## CITY OF GLENDALE, CA

### DESIGN REVIEW STAFF REPORT – SINGLE FAMILY

<b>August 4, 2023</b> <i>Decision Date</i>	<b>316 Allen Avenue</b> <i>Address</i>
<b>Administrative Design Review (ADR)</b> <i>Review Type</i>	<b>5625-010-007</b> <i>APN</i>
<b>PADR-000499-2022</b> <i>Case Number</i>	<b>Arvin Shirinyans</b> <i>Applicant</i>
<b>Chloe Cuffel, Planning Associate</b> <i>Case Planner</i>	<b>Hovhannes Markosyan</b> <i>Owner</i>

The project proposes a new, two-story 1,027 square-foot residential dwelling unit with an attached two-car garage at the rear of an existing 1,434 square-foot single-family dwelling (built in 1931) on a 8,350 square-foot lot. The existing detached, two-car garage will remain at the rear of the property and continue to serve the single-family residence. A stable, attached to the existing two-car garage, will be demolished.

NEW SITE  
PLAN

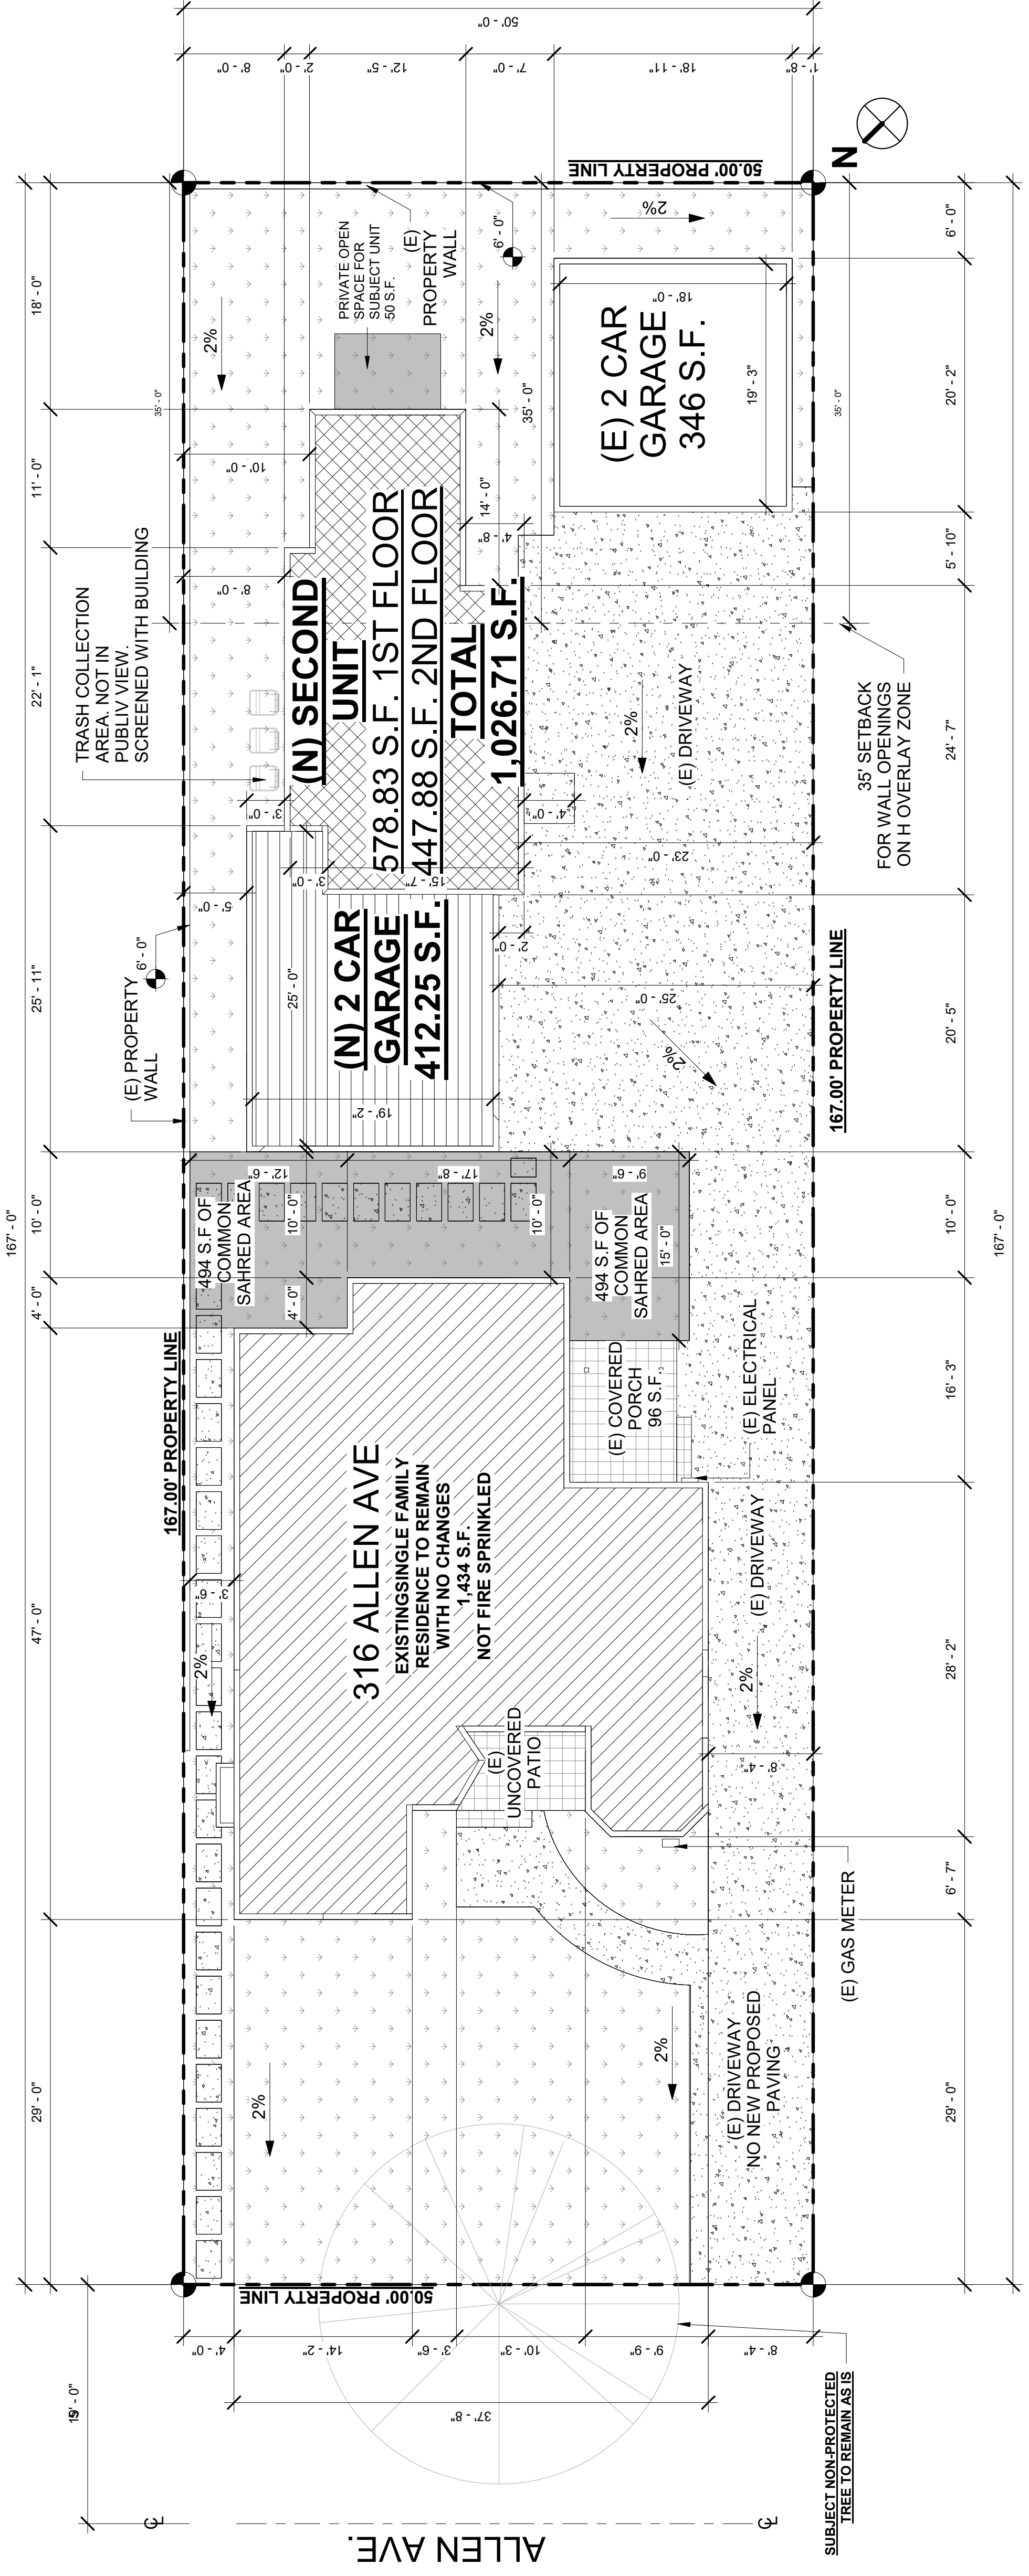
The driveway wide at the front of the house does not comply with Zoning requirements. A condition is included to two-foot wide buffer of live plant material is required, separating the driveway from the walkway in compliance with the Zoning Code.

- The proposed building is appropriately setback from the existing primary residence and property lines.
- The project proposes 33.98 percent landscaping for the entire lot, which complies with the minimum 30 percent required per the Zoning Code. However, a condition is included to provide additional landscape planter at the front of the lot, separating the driveway and walkway by two feet width and at least eighteen inches high of plant material per Zoning code.

1. That a two-foot wide landscaped area be provided, separating the driveway from the walkway in compliance with the Zoning Code.
  2. That the project site be brought into landscaping conformity at the front and rear of the property with 50% of the landscaping being live plant material.
  3. That all gutters be painted to match the adjacent wall color.
-
